**ADDENDUM TO ENVIRONMENTAL (SEPA) DETERMINATION OF
NON-SIGNIFICANCE (DNS-M) - MITIGATED**

**Addendum to the Longacres Business Center
as Addended by the City of Renton (LUA15-000076)
Determination of Non-Significance - Mitigated (DNS-M)**

Project Names: Longacres Business Center

Re: Request for Project Addendum to the ERC Approval, Longacres Business Center Site Plan and Street Modification, Renton, Washington

SHEET TITLE / NUMBER
 SITE PLAN
 A1.1

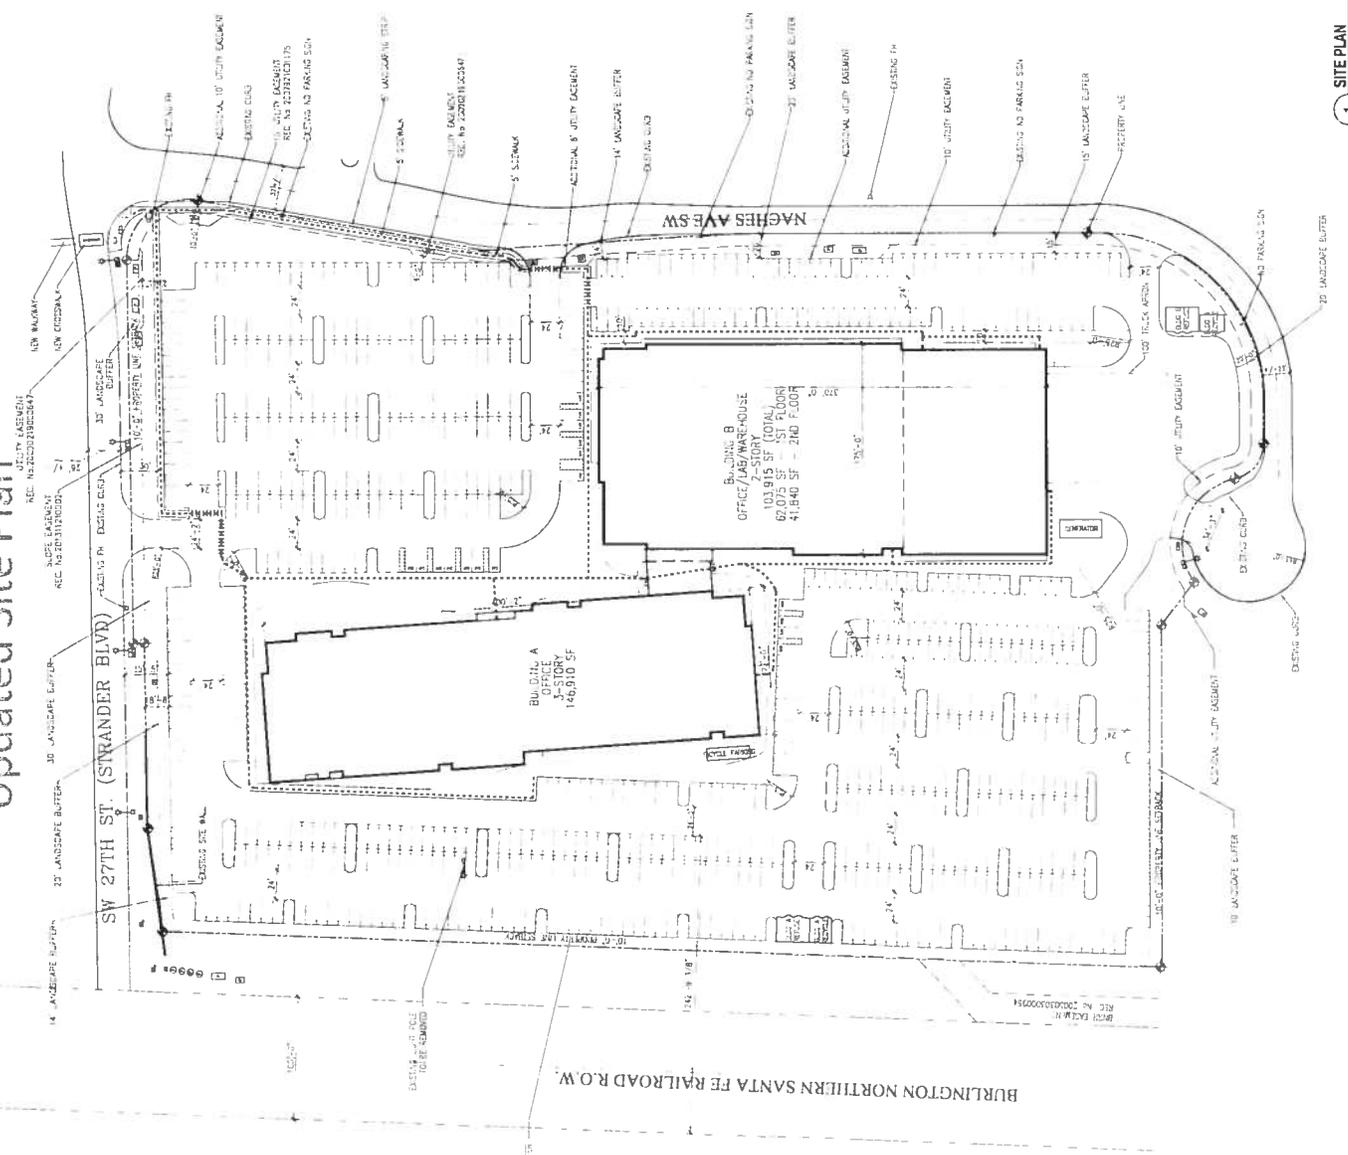
The intended purpose of the subject SEPA Addendum is to disclose the intended changes to the original mitigation measures, specifically 2 and 3. With the Addendum documentation, the applicant has provided a description of the proposed changes to the original site plan along with an updated site plan (attached). The Addendum request was prepared by Molly Ryan Carson dated April 29, 2015. The letter illustrates the proposed modification to generator landscaping, SW 27th St, Naches Ave SW, and the location of the water main associated with the project.

The attached site plan includes landscaping to the west of the generator. Adding landscaping to the south of the generator would affect parking, access to truck apron and general ingress and egress for the project. Additional landscaping would also cause difficulties accessing the generator for maintenance and repairs.

Following our original submittal, we incorporated a 30' landscape buffer along the majority of SW 27th as requested by the City. The landscape buffer tapers to 20' then 14' at the far west of the site due to site constraints and the change in elevation on the north western corner of the site. The tapering of the landscape set back is also required to maintain our parking ratio as is. Additionally, the updated plan shows a pedestrian path on site that allows for safe travel through our site to the crosswalk at the corner of SW 27th and Naches Ave. As we discussed, maintaining a clear, safe pathway for Group Health's employees is of paramount importance.

The plan identifies a 5' sidewalk and 5' landscape strip from the corner of SW 27th St and Naches Ave. south to our employee entrance. From that entrance our pedestrian traffic moves into our site and along the front of building B. We've increased the sidewalk width along the building (B) to a spacious 10', allowing for a comfortable and pleasing pedestrian experience. This 10' sidewalk terminates at the far south corner of the building. As discussed, it is our and Group Health's strong desire to minimize pedestrian traffic any further south on the site, from a safety and security perspective. This is our back of house area, with truck traffic and the shipping and receiving of sensitive material.

2. The applicant shall provide a convenient and pedestrian friendly sidewalk from the intersection of SW 27th Street (Strander Blvd) and Naches Ave SW to the northern portion of Building A. The sidewalk shall be a minimum of 5 feet wide and may be located behind the 30-foot wide landscape berm on SW 27th Street.

3. The applicant shall provide a minimum 30-foot wide landscaped buffer along the majority of SW 27th Street with a berm. The width of the buffer may taper to 20 feet then 14 feet at the far northwest portion of the site, or near the existing retaining wall.
